Access Compliance Report Public Rights-of-Way (Curb Ramps)

Main Street: RAINIER_DR Cross Street: YORBA_ST Location: S

ADA ID: RPRK211006151942 Ramp Type: Type 1 - Perpendicular Diagonal Initial Pass/Fail: Fail Overall Compliance: No Severity Score: 15

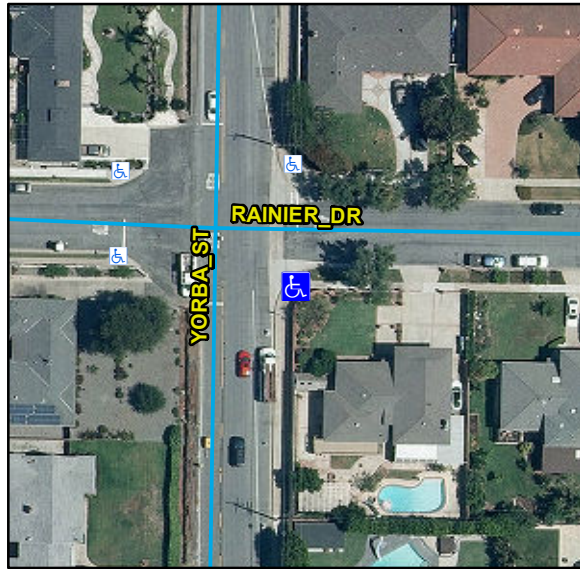
Compliance	Description	Data	Compliance	Description	Data
N/A	Ramp Length (in)	75	N/A	Flare Type LT	
Yes	Ramp Width (in)	48			N/A
No	Ramp Run Slope (%)	12	N/A	Flare Slope LT (%)	N/A
Yes	Ramp Cross Slope (%)	0.5	N/A	Flare Traversable LT	N/A
N/A	Landing Present	N/A	N/A	Flare Type RT	
N/A	Landing Length (in)	N/A			N/A
N/A	Landing Width (in)	N/A	N/A	Flare Slope RT (%)	N/A
N/A	Landing Run Slope (%)	N/A	N/A	Flare Traversable RT	N/A
N/A	Landing Cross Slope (%)	N/A	N/A	DWS Provided	N/A
N/A	Landing Movement Obstructed?	N/A	N/A	DWS Contrast	N/A
	Landing Movement Type	N/A	N/A	DWS Length (in)	N/A
N/A	Landing Shared	N/A	N/A	DWS Full Width	N/A
N/A	Clear Space	Yes	N/A	DWS Offset Left (in)	N/A
N/A	Clear Space To Crosswalk (in)	N/A	N/A	DWS Offset Right (in)	N/A
N/A	Marked Crosswalk 1	No	N/A	Marked Crosswalk 2	No
	Crossing 1 Direction	N		Crossing 2 Direction	E
	Marked Crosswalk 1 Width (in)	N/A		Marked Crosswalk 2 Width (in)	N/A

N/A	Ramp Inside Crosswalk 1	N/A	Yes	Ramp Inside Crosswalk 2	N/A
	Crossing 1 Slope (%)	10.7		Crossing 2 Slope (%)	4.6
	Crossing 1 Cross Slope (%)	3.7		Crossing 2 Cross Slope (%)	0.8
N/A	Gutter Ponding	N/A	No	Curb Slope	7.4
No	Gutter Lip Height (in)	0.25		Road Run Slope (%)	5
N/A	Gutter Run Slope (%)	N/A		Road Cross Slope (%)	3.6
N/A	Gutter Cross Slope (%)	N/A			
Yes	Overall Surface Condition: Acceptable		Yes	Perp Joint Present	Yes
	Cross Gutter Present?	Yes		Spandrel Present?	Yes
	Replace Cross Gutter?	No		Replace Spandrel?	No

Remove & Replace Curb Ramp With Two New Directional Ramps or Equivalent.

R304.2.2, R302.7.2, STD 1115
